**Illinois Tollway Standard Drawings Revisions**

| Section L    |   | Fiber Optic           |  |
| Standard     | Modification Summary  | Effective: 03-01-2025 |  |
| <b>L1-07</b> | <b>Fiber Optic System Typical and Drawings</b>  |                       |  |

**TORSION ASSIST COVER**

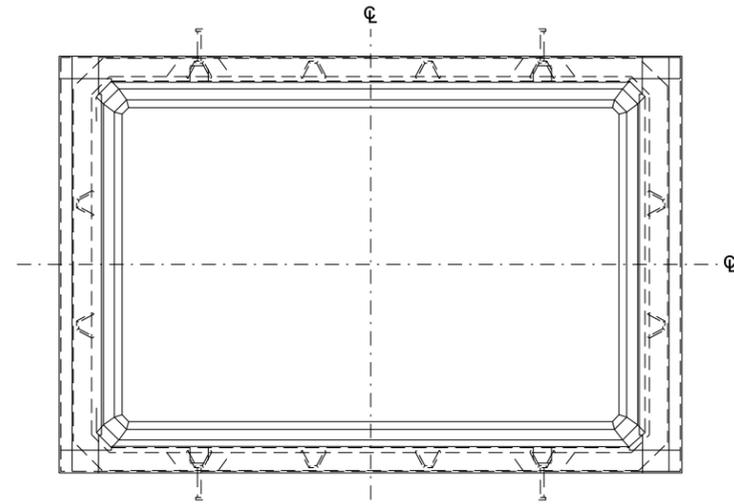
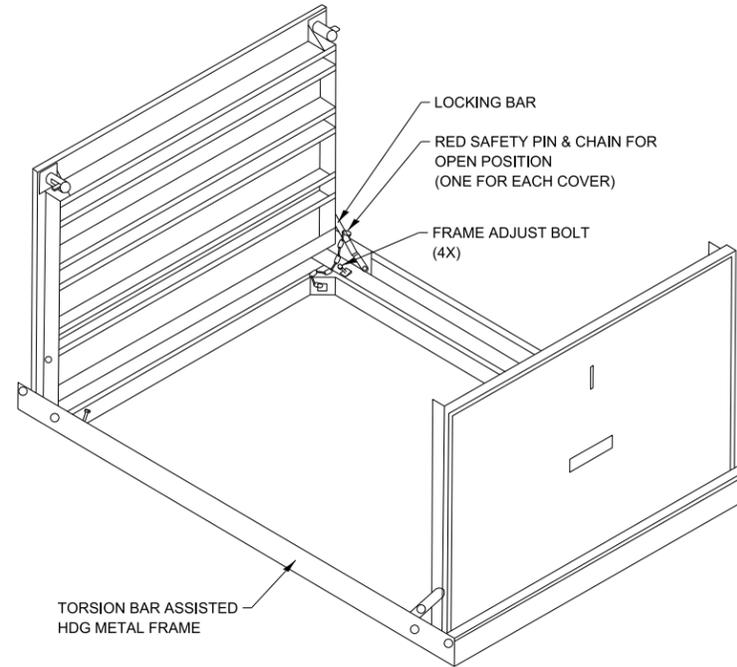
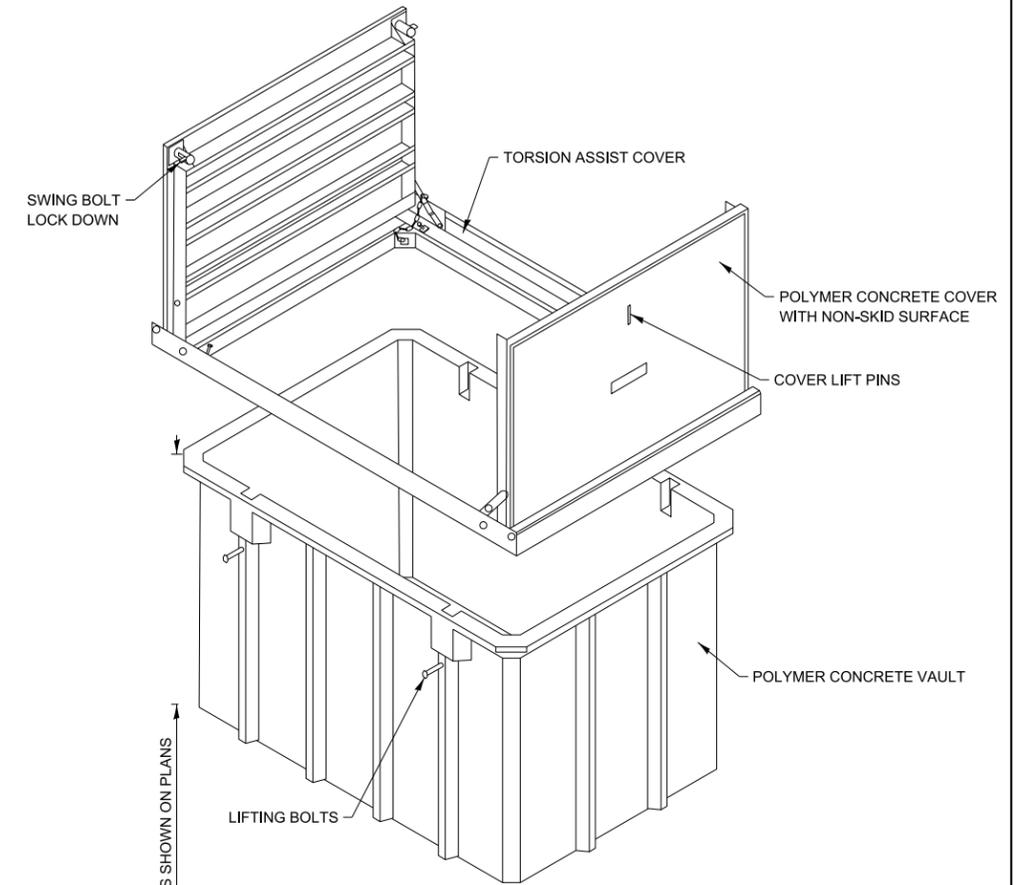
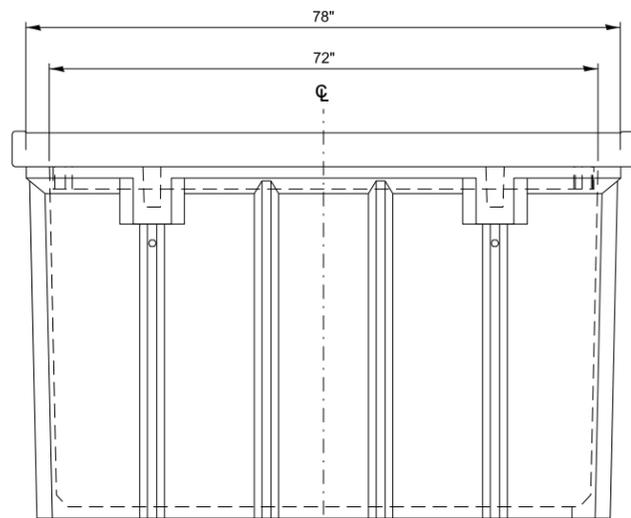
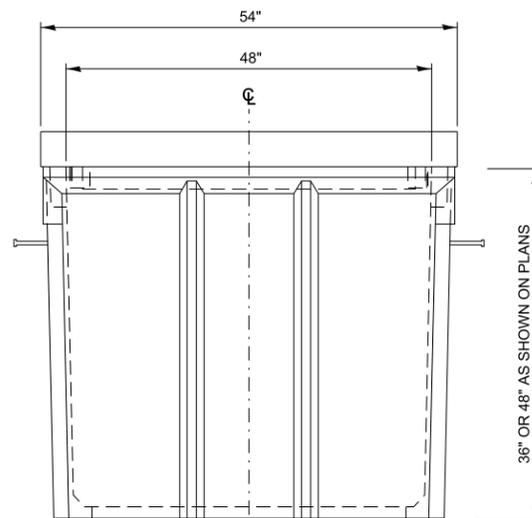
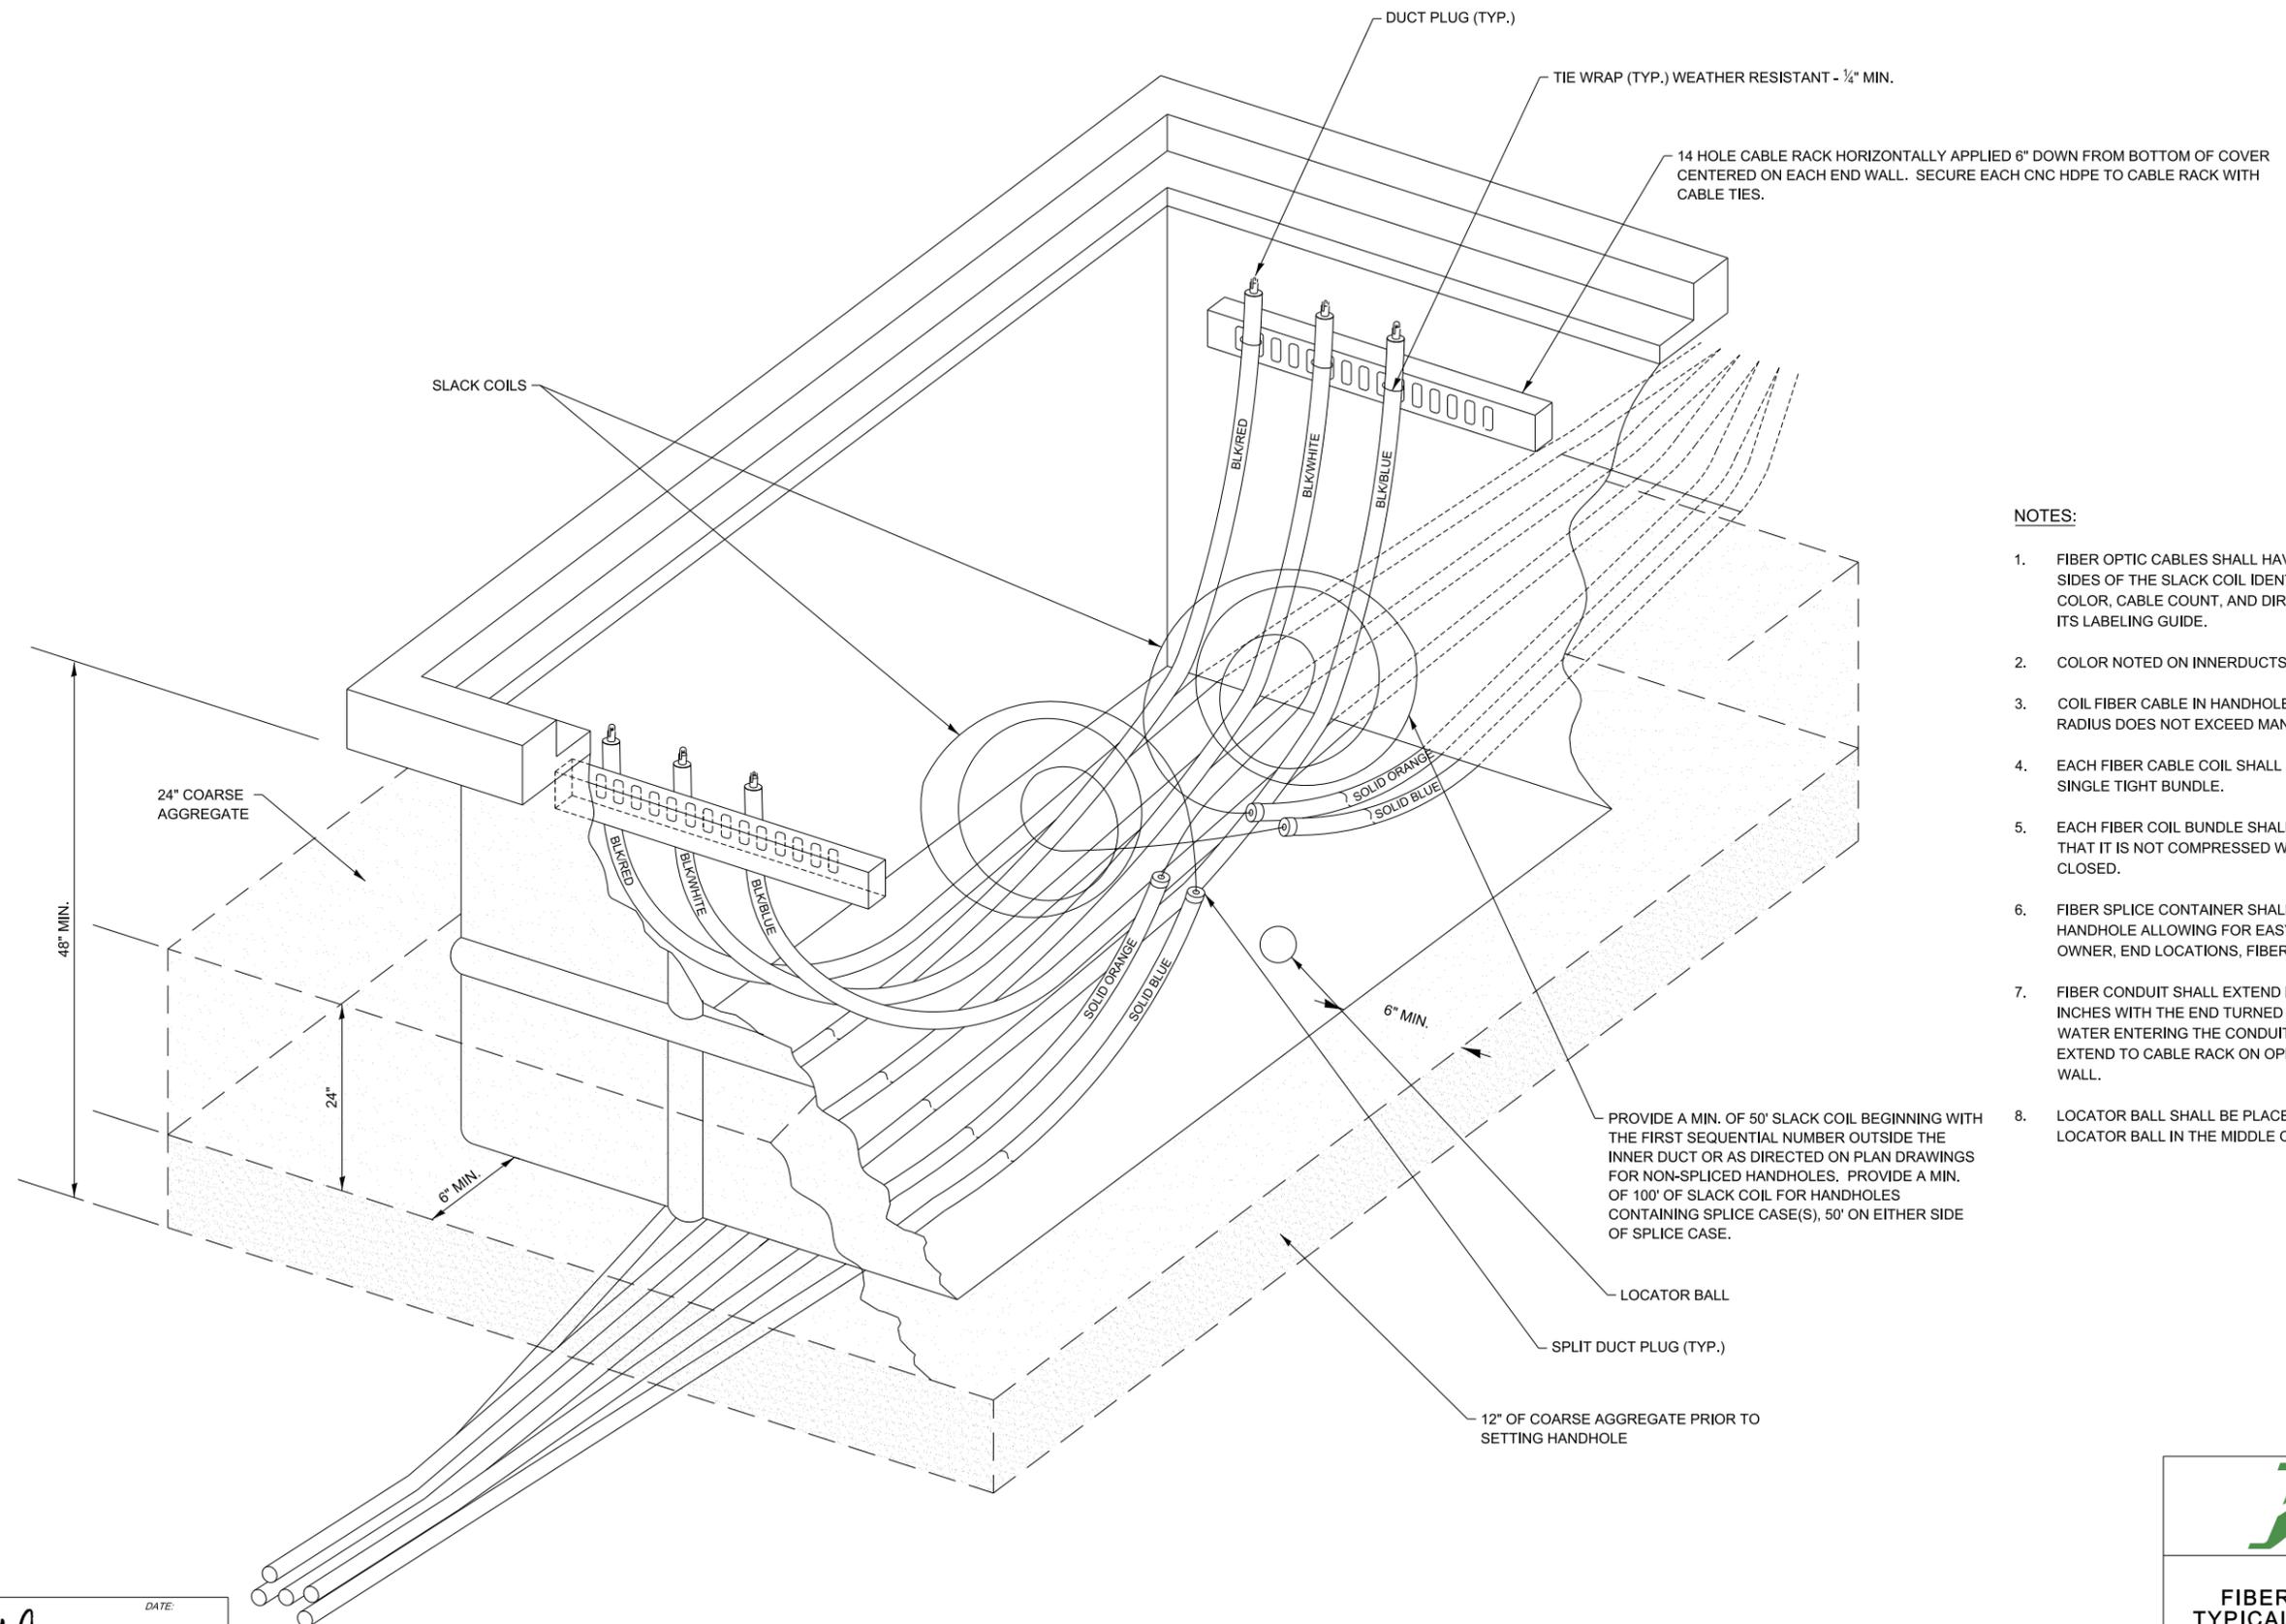
| Section L    |   | Fiber Optic           |  |
|--------------|---|-----------------------|--|
| Sheet 7      | Added "locking bar" callout to Torsion Assist Cover detail.   |                       |  |
|              | Added Note 2.   |                       |  |
|              | Added Note 3.   |                       |  |
|              | Removed statement "for fiber optic cable splice locations and slopes greater than or equal to 1:4".   |                       |  |

| VERSION:<br>2025-03 | STANDARD:<br>L1-07 | SHEET:<br>8 OF 15 |

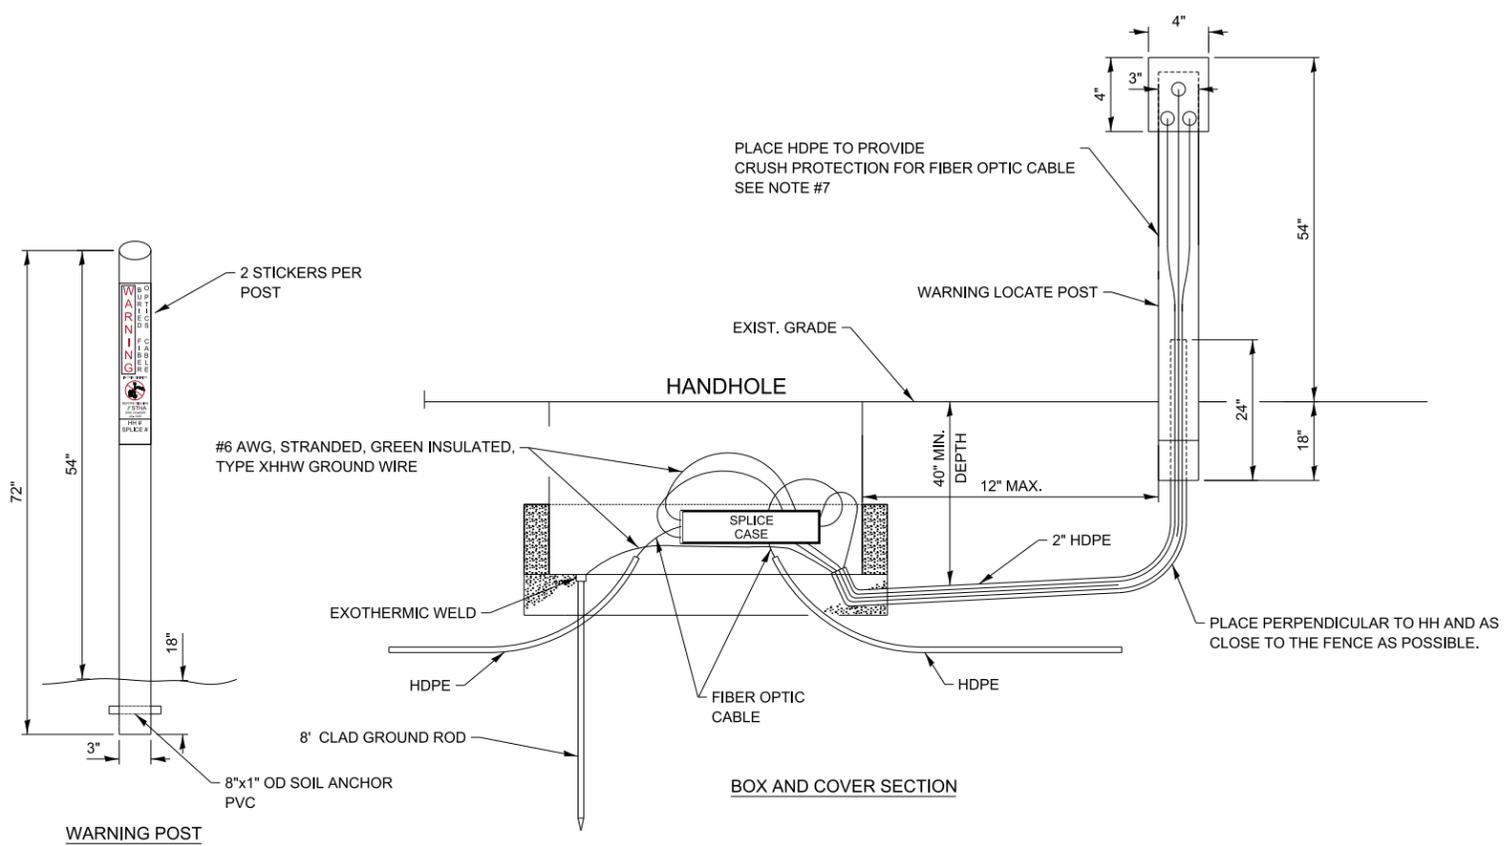
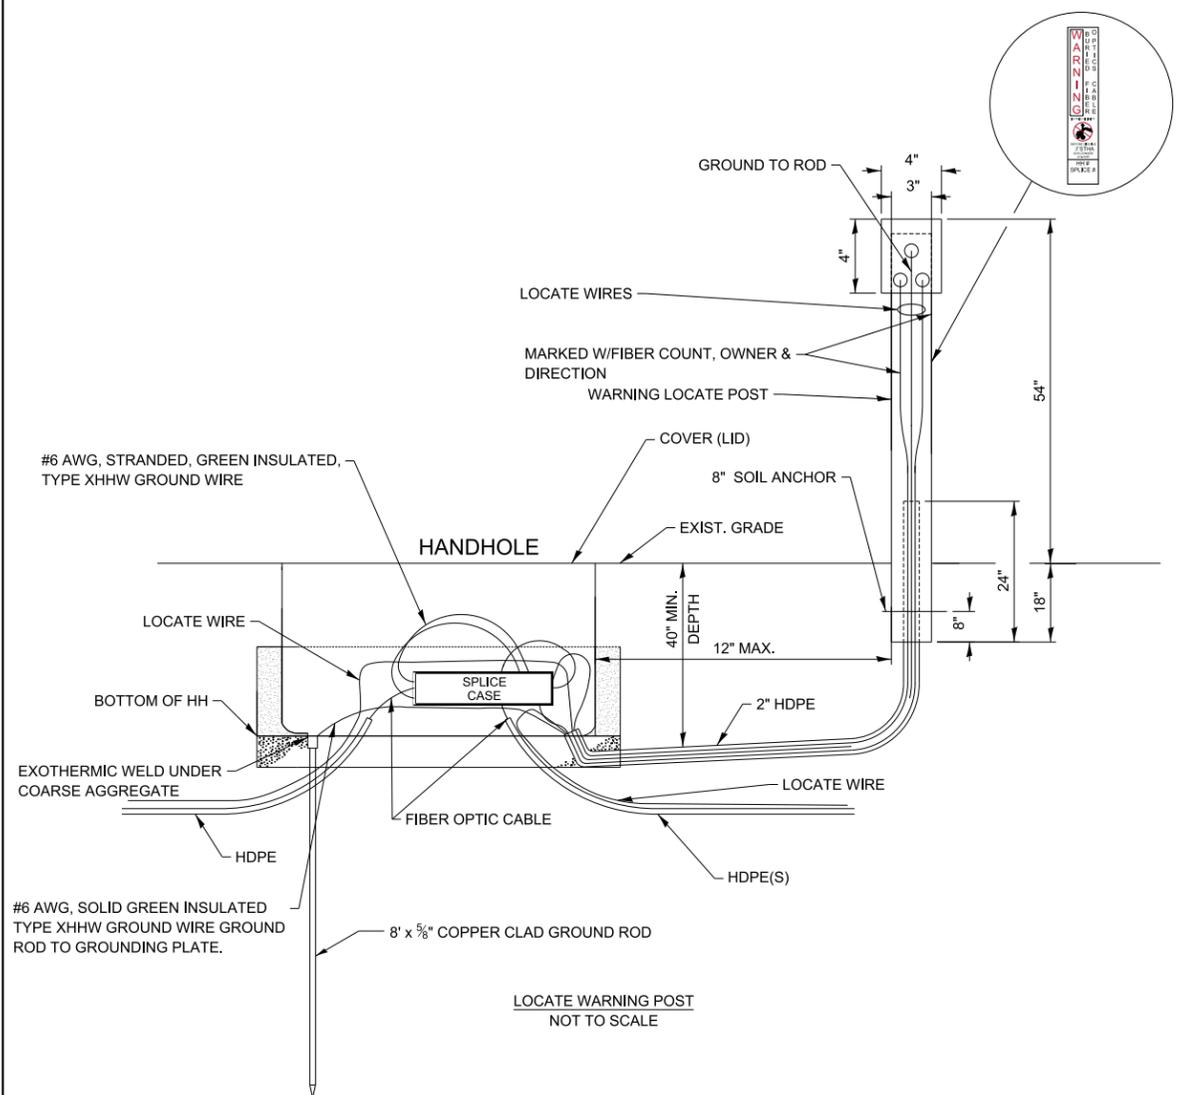
| Section L    |   | Fiber Optic           |  |
|--------------|---|-----------------------|--|
| Sheet 8      | Removed "Table A".  |                       |  |
|              | Updated minimum depth below handhole rim from 42" to 48" on detail drawing.   |                       |  |
|              | Deleted cable tags from detail.   |                       |  |
|              | Removed "Sample Cable Tag".   |                       |  |
|              | Added "reference the ITS Labeling Guide" in Note 1.   |                       |  |
|              | Replaced "meets the values in Table A" with "does not exceed manufacturer specifications" in Note 3.  |                       |  |
